Groundwater Transfer Review Summary Form

Transfer/PA # T- 14515

Application: T-14515

Applicant Name: Walkdale Farms, LLC

Well-to-Well Interference Analysis (Theis, 1935): Well 3 to POLK 1269

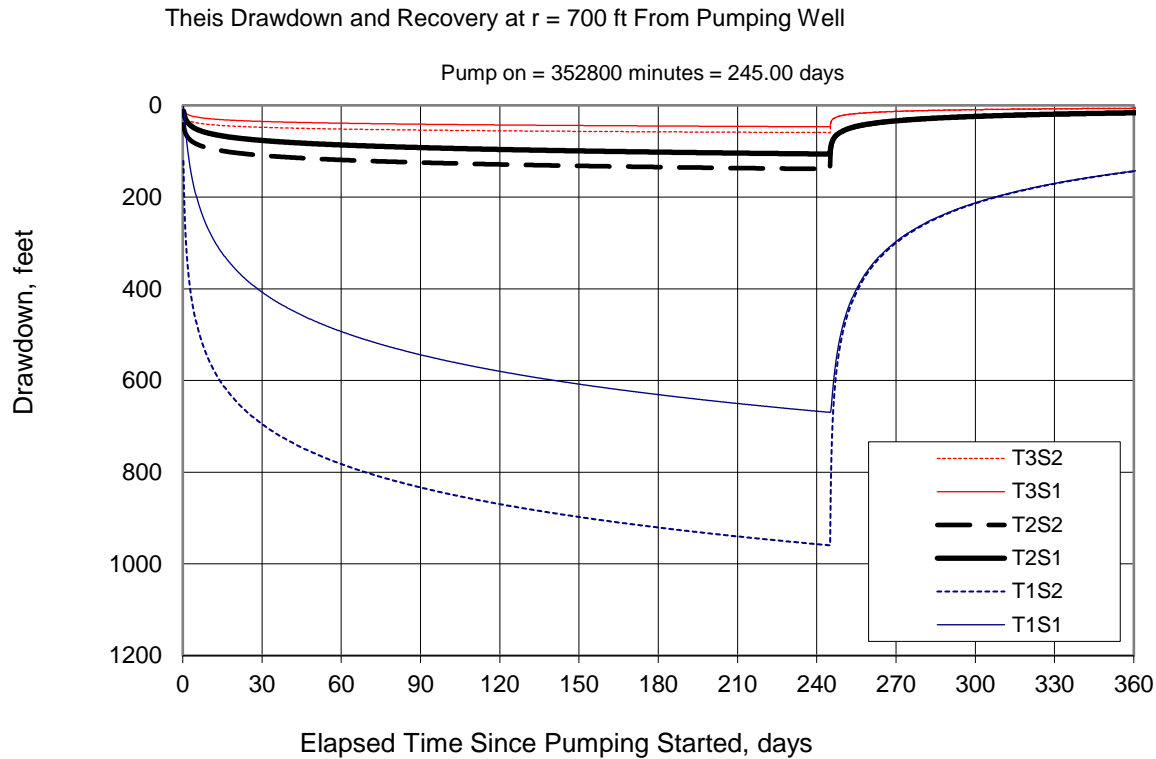
Pumping rate, $Q = 0.33$ cfs [maximum rate authorized by Certificate 97529]

Pumping time, $t_{\text{pump}} = 245$ days [irrigation season]

Transmissivity: $T1^* = 17$ ft²/day | $T2^* = 160$ ft²/day | $T3 = 410$ ft²/day [Pumping test reports]

Storativity: $S1 = 0.0001$ | $S2 = 0.00001$ [Conlon et al., 2005]

*NOTE: The highest levels of interference under the T1 and T2 scenarios are not physically attainable due to the limited well depth/aquifer thickness. Well to well interference would still be expected to be high under the proposed pumping rate for these scenarios, but the pumping well would dry up and have to be shut off once water levels declined below the pump intake level.

POLK 1269 Injury Threshold

Unit	Source
Depth to water	35 ft bls	Log MARI 2362
Total depth	100 ft bls	Assumed full penetration depth
Water Column	65 ft	
Min Avail Drawdown	25 ft	Well report specific capacity (1 gpm/ft) x Rate of GR-3313 (25 gpm)
Pump buffer	10 ft	
Min Water Column	35 ft	
Interference Threshold	30 ft

- b) If yes, would this proposed change, at its maximum allowed rate of use, likely result in another groundwater right not receiving the water to which it is legally entitled?
☒ Yes ☐ No If yes, explain: Proposed APOA "Well 3" is ~700 ft northeast of POLK 1269 and is the closest of the proposed APOA wells. Interference with POLK 1269 was analyzed using the Theis (1935) solution for drawdown in a confined aquifer (see attached Well-to-Well Interference Analysis). **Results of the analysis indicate the proposed change will likely result in injury to POLK 1269.** This finding could be overcome by conducting a multi-well aquifer test demonstrating that the level of interference with POLK 1269 will be less than the threshold for injury. Alternatively, the applicant could lower the requested rate for Wells 2 and 3 to less than 0.08 cfs combined, in which case, injury to POLK 1269 would not be likely.
